Service Letter

Title: SL-374 Bell 412 Compressor Drive Pulley Belt Guard Change

Date: December 6, 2016

Applicability: Bell Helicopter 412 Aircraft equipped with the Air Comm Air Conditioning System, all serial numbers. The system serial number is marked on the compressor mount.

Figure 1. Compressor Drive Installation View

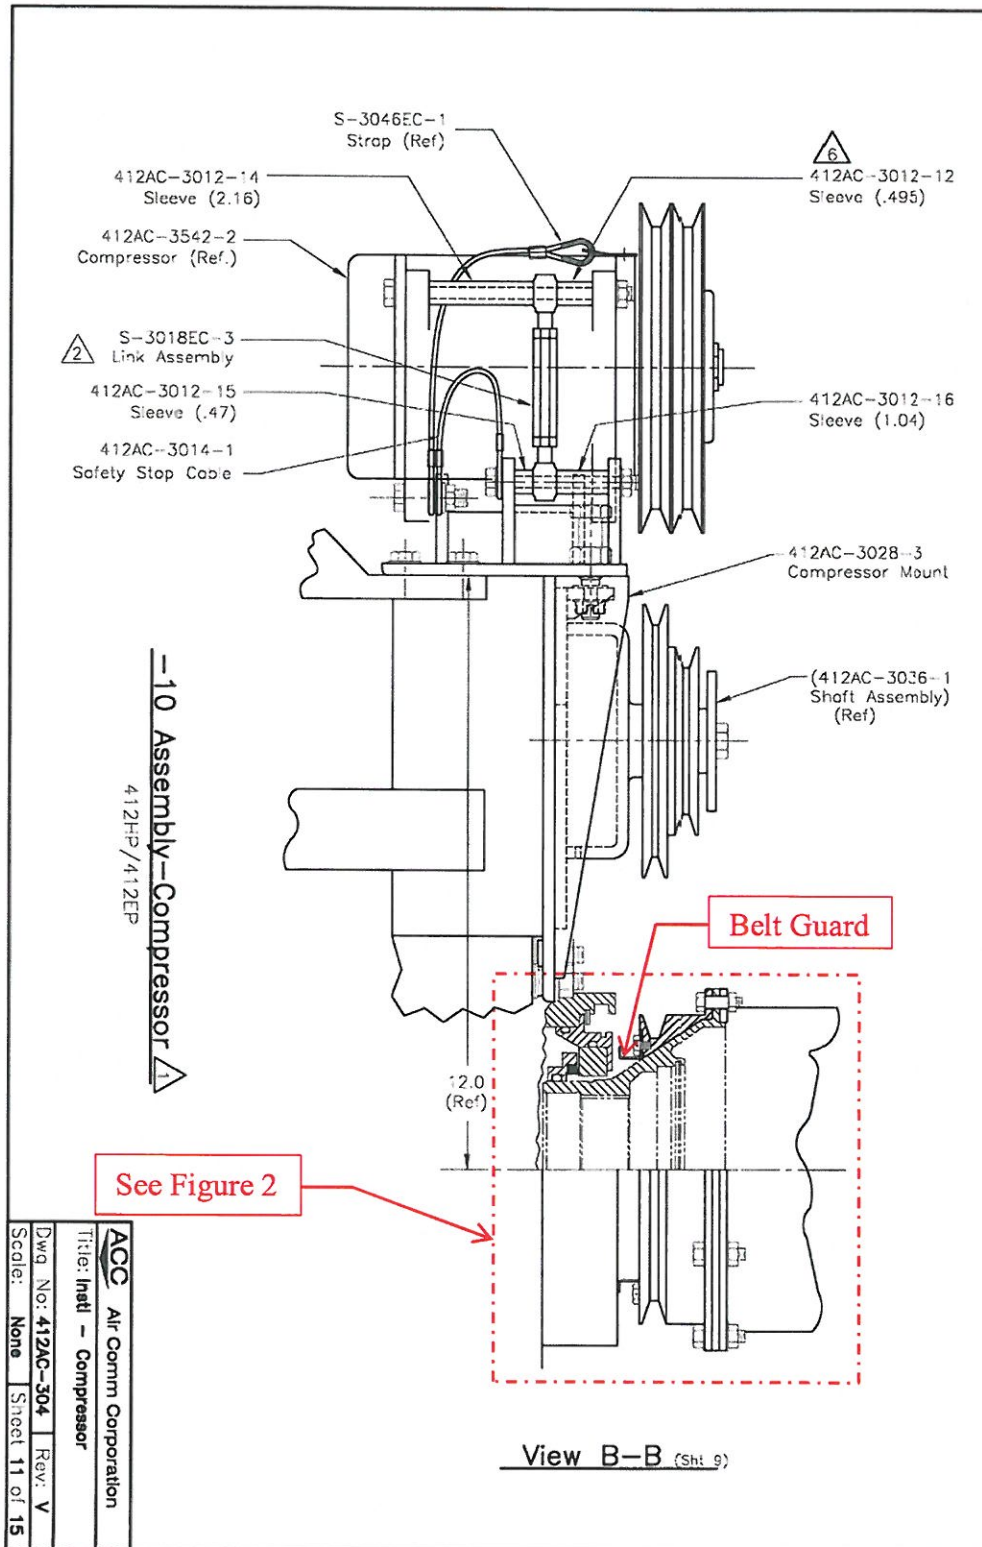
An operator has reported finding a severed compressor drive belt and belt guard that was dislodged and damaged. The issue was believed to have been due to the belt guard fasteners loosening, allowing the guard to dislodge and contact the drive belt. This service bulletin provides information to ensure the security of the belt guard fasteners.

- 1) Referring to Figures 1 & 2 above, ensure that the lock wire and NAS1802 screws securing the belt guard to the pulley are all in place.
- 2) If any anomalies are found, remove the lockwire and torque the 8 screws to 35-40 in-lb. Note that per the 412AC-304 Compressor Installation drawing the torques had been specified to be 12-15 in-lb.
- 3) Re-install lockwire MS20995C-32 per QQ-W-423B Cond. A

Revision	Issue Date	Inserted By	Approved by	Description of Changes
NC	10/13/16	JMB	BD	Initial Release
A	11/22/16	JMB	KM	Edited Compliance statement to include recurring inspection info.
B	11/29/16	JMB	KM	Sh 3: Added ref. original torque values to step 2.
C	12/06/16	JMB	<i>KM</i>	Sh 3: screw torque value was 60-65 in-lb, changed to 35-40 in-lb to align w/Bell standards
